2.2.7 AMENDMENT 19: CPH

Removal of slab to retail unit 05 west facade

APPROVED PLAN
Drawing: 19404-CPA First Floor Plan

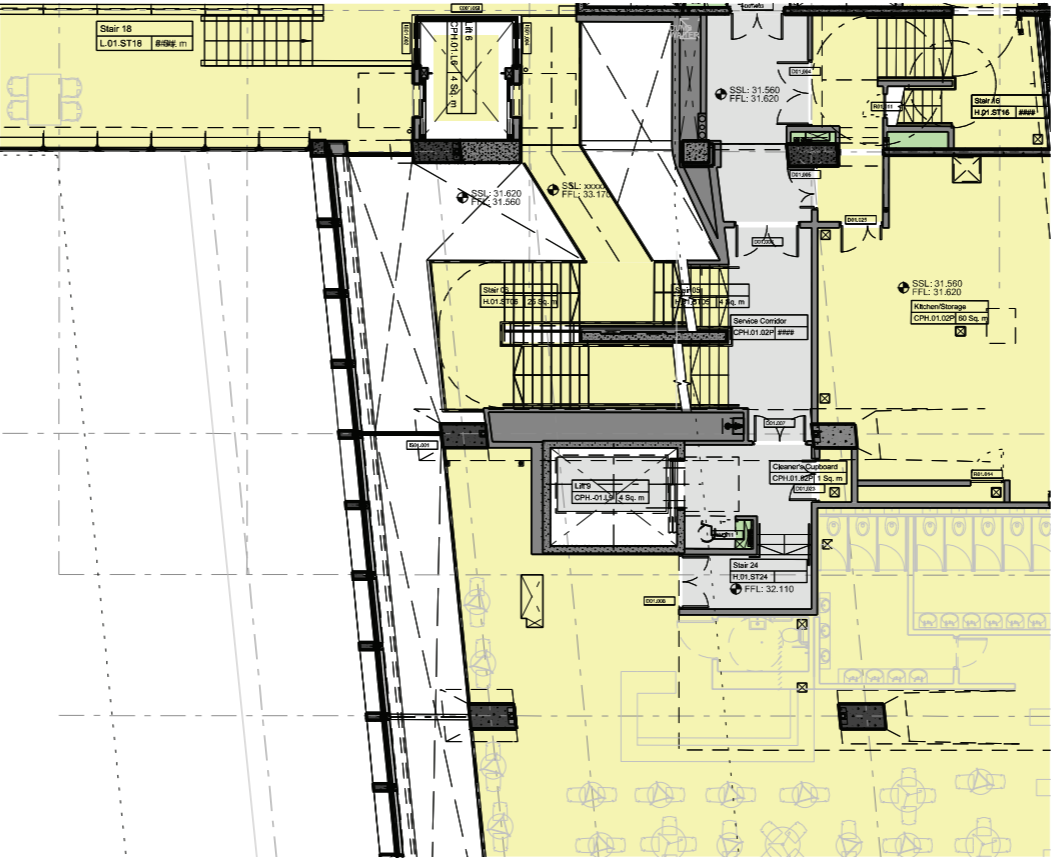
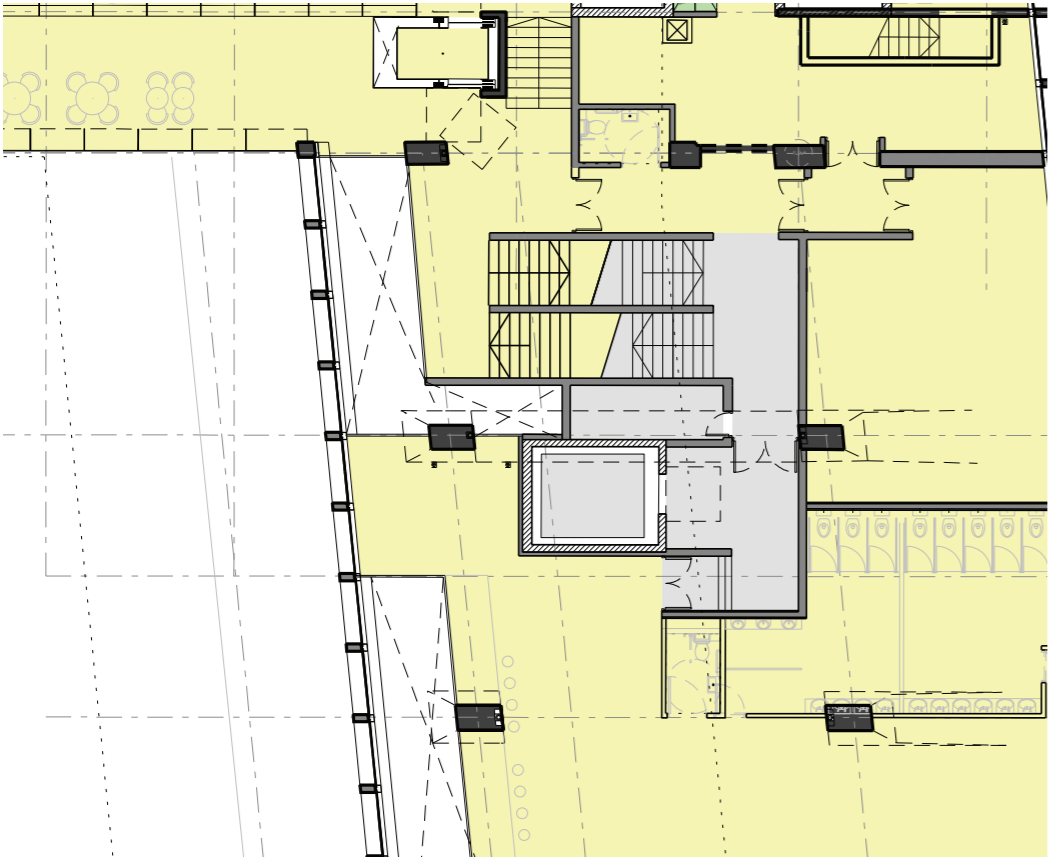
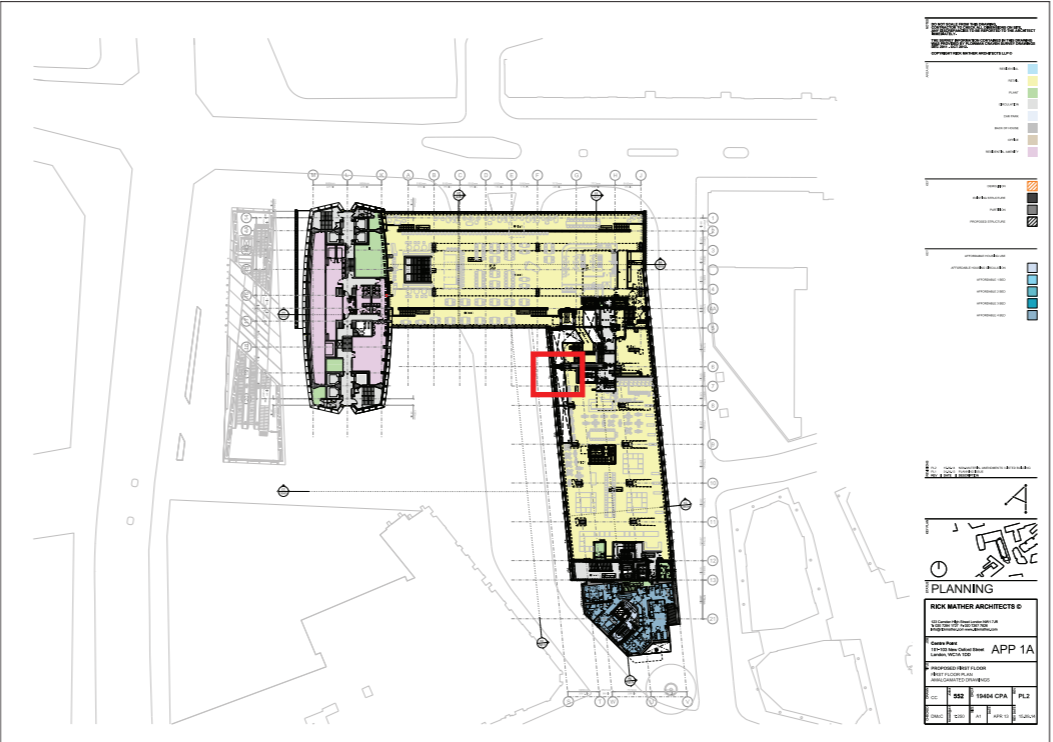
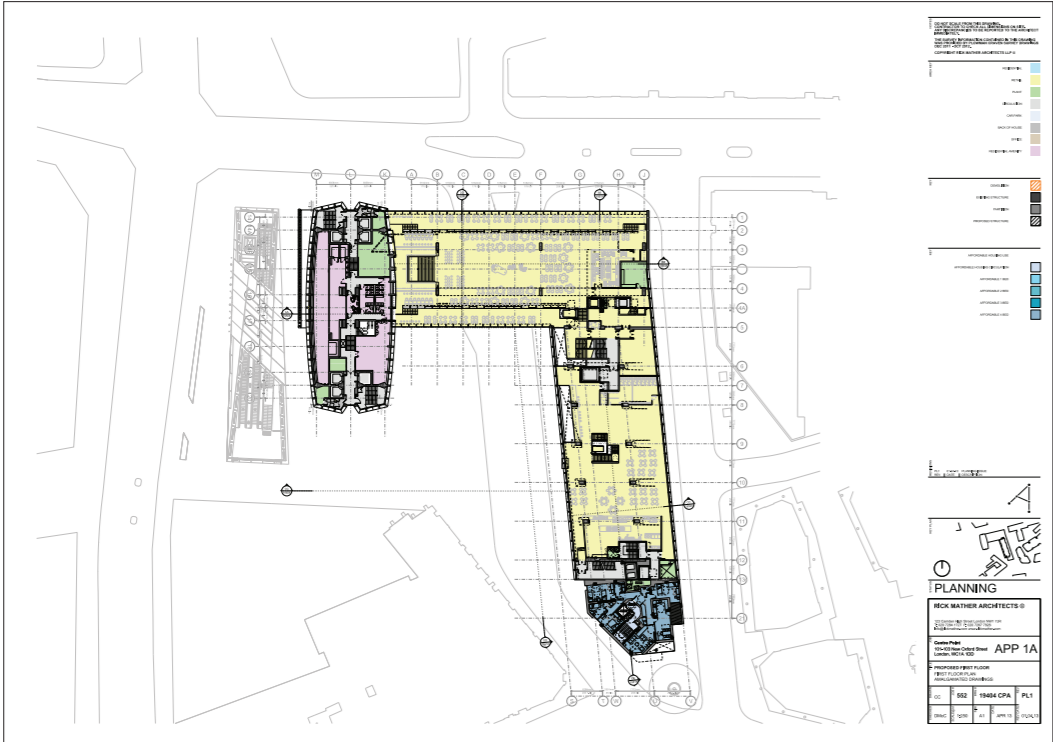
The design incorporates a quadruple height void at the main entrance on the West elevation. This allows a greater appreciation of the brise soleil internally and a strong visual connection to and from the adjoining retail units across the entrance lobby. However, in the approved scheme this was compromised to a certain extent by the need to retain the existing level 01 slab (between gridlines 6 & 7). This section of slab was required to brace the existing facade but provided a significant visual obstruction.

Subsequent detailed structural design has meant this section of slab is no longer necessary and we are therefore proposing to omit this and provide a visually clearer and more dramatic entrance void area.
